We thank the reviewer for the thorough and constructive feedback. Below, we address each point in detail and indicate the corresponding changes in the revised manuscript.

"Probability Assessment of Static Overload in Wind Turbine Blade Bearings Considering Turbulence, Design, and Manufacturing Variability"

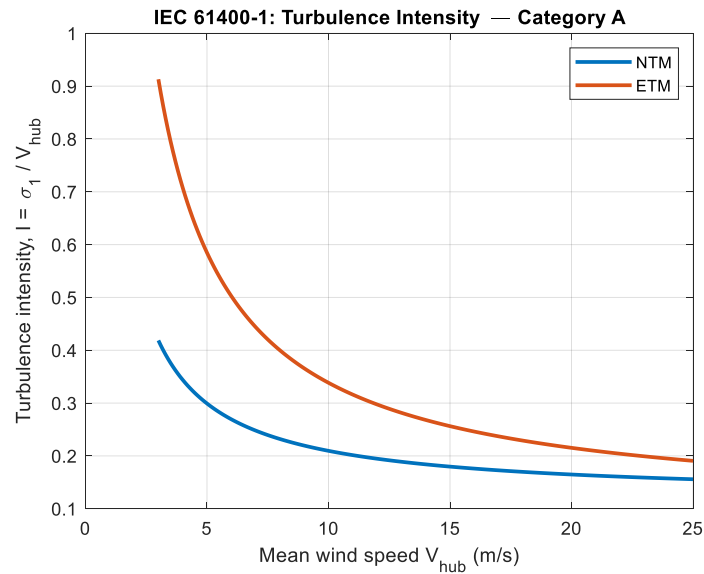
- In Table 3, the reference wind speeds and reference turbulence intensities are shown for classes A+, A, B, and C and the 13 actual wind sites are only mentioned. No corresponding characteristics are given for the 13 sites (other than pointing the reader to Rezai and Nejad, 2023). Later, however, the most relevant information for the 13 sites is described in Section 3.3 (titled Description of DLC). There, “extreme” turbulence intensities are listed, but I am not sure I understand what an “extreme” TI is. Is it just the calculated TI at the site as described by IEC 61400-1 (i.e. ratio of the wind speed standard deviation to the mean wind speed), which for most of these are higher than standard IEC classes (and thence “extreme”)? I recommend that Table 6 be moved from Section 3.3 to Section 2.3. Or am I entirely missing something? Why is the description of the TI at the sites, which is an important part of the analysis, not in the Section 2.3 Wind sites? Is there something to “extreme” TI, compared to the reference TI? This becomes important later in Section 3.3 where the DLC and turbulence models are introduced. It’s even more important in Section 4 and 5 that describe the effect of turbulence on the probability of failure.

- Line 242 and Table 6: I am not sure I understand the transition between the discussion of DLC 1.3 and the site characteristics in Table 6 and “extreme” turbulence intensity. As mentioned earlier, why is this Table not in Section 2.3? Are these extreme values calculated differently than normal and thus not comparable to reference TIs? For 10 m/s for instance, the values of 0.65 and 0.87 for 2 of the sites are extremely high. It is no surprise then that later these sites lead to a higher probability of failure compared to a reference turbulence intensity of 0.16 for IEC 1A.

The extreme turbulence value table is moved to section 2.3.

IEC 61400-1 defines two different turbulence models: Normal and Extreme. In IEC 61400, the normal turbulence model (NTM) follows equation 10, but the extreme turbulence model (ETM) follows equation 20. ETM is higher than NTM because it represents extreme and rare cases and therefore exceeds NTM across all wind speeds. The reference TI commonly quoted for turbulence classes is defined at $V_{hub} = 15$ m/s under NTM, and it differs from extreme turbulence. The plot of ETM and NTM for IEC class IA is shown below.

In this study, extreme turbulence intensity means the maximum turbulence intensity in each wind speed range at the site, and extreme turbulence intensity for the IEC wind classes is directly calculated by TurbSim.

The table moved to section 2.3. As stated previously, the calculation of turbulence intensity is the same as normal turbulence intensity, but these values are extreme cases of turbulence intensities of one year of wind data. As mentioned before reference turbulence intensity referred to the wind speed of 15 m/s in the normal turbulence wind model. For example, as shown in the figure related to the comment on Section 2.3, normal turbulence of wind speed 15 m/s in IEC 1A is equivalent to 0.18, while its extreme turbulence is 0.26. For wind speed 10 m/s, TI in NTM and ETM are 0.21 and 0.34, respectively. The values of 0.65 and 0.87 in the sites are extremely high, and we accept that it is the main reason for the high probability of failure. These
